SILVERADO SUBDIVSION

MASTER DEVELOPMENT PLAN
OCTOBER.2006

Re: Silverado Sub. Master Development Plan **MDP # 024-06**

The City Staff Development Review Committee has reviewed the Silverado Subdivision Master Development Plan **M.D.P. # 024-06**. Please find enclosed a signed copy for your files. Your plan was approved for acceptance; however please note the following conditions:

P1

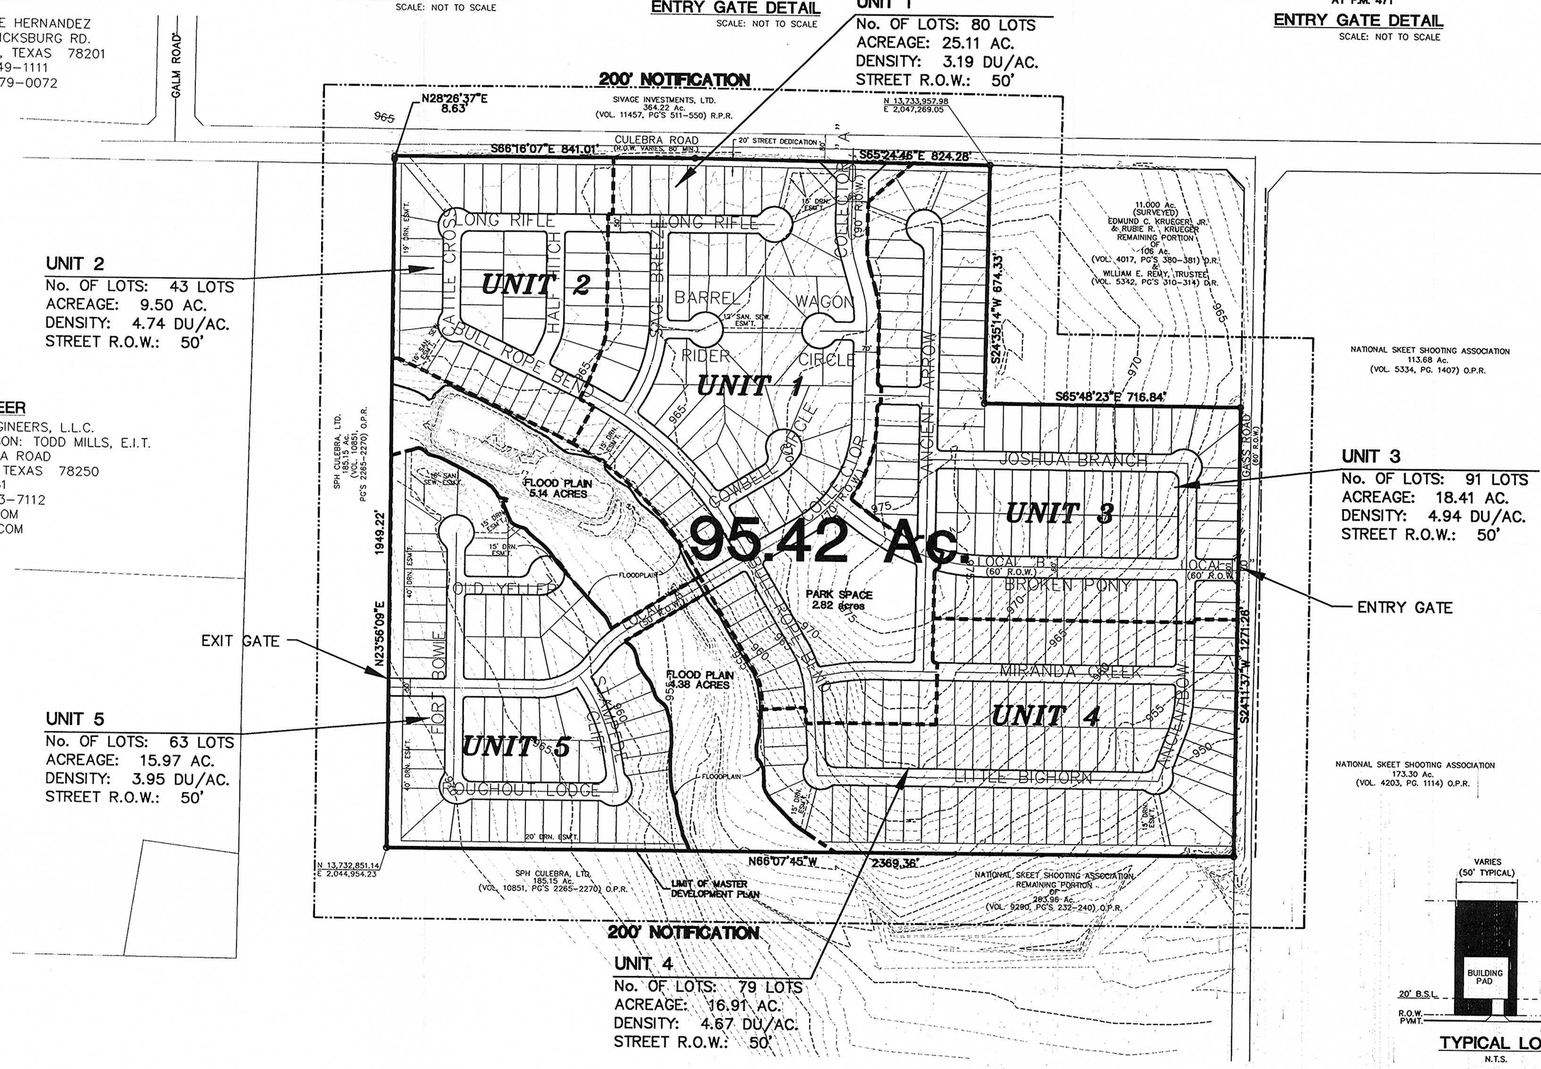
In consideration of public safety and convenience, excessive grades by reason of topography should be avoided in street layouts and arrangements. Any access and R.O.W. issues along state facilities will need to be resolved with the **Texas Department of Transportation (TXDOT)**. For information about these requirements you can contact TXDOT at 615-5814.

DSD – **Traffic Impact Analysis & Streets** indicate that under the UDC listed below are some of the requirements and onsite improvements that are necessary and shall be provided by the developer, on and before the completion of the Silverado Sub. MDP, at no cost to the City of San Antonio:

- All roadways shall follow Table 506-7, Functional Classification System Description and shall comply with UDC 35-502(a)(9).
- All access roadways shall provide clear sight distance on all existing and proposed roadways in order to provide adequate obstruction free viewing distances for approaching traffic. All signage, landscaping, and improvements shall be selected and located so as to not block these clear sight distance areas.
- The developer shall be responsible for providing a left-turn lane, with storage length and by taper per TxDOT design standards as it relates to the submitted TIA traffic counts, at Culebra and Gass Road UDC 35-502(a)(7), subsection C.
- Sidewalks along all interior and exterior roadways are to be installed in accordance with UDC 35-506(q).

Parks and Recreation recommends approval with the following conditions:

- The parkland provided is dedicated to the 'Homeowners' Association.
- A Provision and Maintenance Plan is provided to this department at the time of platting.

Trees states that this project will be subject to:

- 2003 Tree Preservation ordinance standards per UDC Section 35-523 – a Tree Preservation Plan is required prior to any work on site. This can be submitted either as a site work permit or at the platting stage.
- Streetscape standards per UDC Section 35-512 – Streets identified as collectors require streetscape will require streetscaping (we recommend preservation of existing trees where available and possible.)
- Additional permitting fees and affidavits will be needed to obtain tree permits during the platting and/or building permit stages.

The property must be platted in accordance to the UDC and the Major Thoroughfare Plan to reflect the approved MDP. It is suggested to work closely with the school district, so they can plan accordingly.
